Access Compliance Report

Public Rights-of-Way

(Pedestrian Signals)

Intersection ID: N/A	Main Street:	Cross Street: N/A	Location: N/A
ADA ID: 1B13061219F0	Signal Type: Two Push Buttons-Non APS	Overall Compliance: No	Severity Score: BTN 1:N/A BTN 2: N/A No BTN: N/A
Codes/Mitigation Info/Possible Solution		Field Measurements/Component Compliance

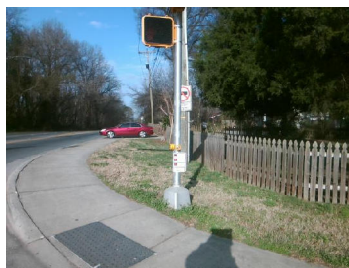
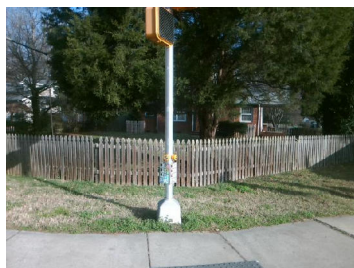
N/A	B 1 FWD Approach Width (in)	N/A	N/A	B 2 FWD Approach Width (in)	N/A
N/A	B 1 FWD Approach Obstruction?	Yes	N/A	B 2 FWD Approach Obstruction?	Yes
N/A	B 1 FWD Approach Obstruction Dist (in)	4.0	N/A	B 2 FWD Approach ObstructionDist (in)	4.0
N/A	B 1 PARA Approach?	Yes	N/A	B 2 PARA Approach?	Yes
N/A	B 1 PARA Approach Constrained?	Yes	N/A	B 2 PARA Approach Constrained?	Yes
Yes	B 1 PARA Approach Reach (in)	7.0	Yes	B 2 PARA Approach Reach (in)	7.0
No	B 1 PARA Approach Width (in)	48.0	No	B 2 PARA Approach Width (in)	48.0
N/A	B 1 PARA Approach Obstruction?	Yes	N/A	B 2 PARA Approach Obstruction?	Yes
N/A	B 1 PARA Approach Obstruction Dist (in)	4.0	N/A	B 2 PARA Approach ObstructionDist (in)	4.0
No	B 1 Clear Floor Space Slope (%)	6.2	No	B 2 Clear Floor Space Slope (%)	6.3
No	B 1 Clear Floor Space XSlope (%)	3.9	No	B 2 Clear Floor Space XSlope (%)	4.9
N/A	B 1 PAR Slope (%)	N/A	N/A	B 2 PAR Slope (%)	N/A
Yes	B 1 Height (in)	40.0	Yes	B 2 Height (in)	40.0

Possible Solutions: Remove and Replace Clear Space.

PROW/ADA: R404.2, R404.3, R404.7.2
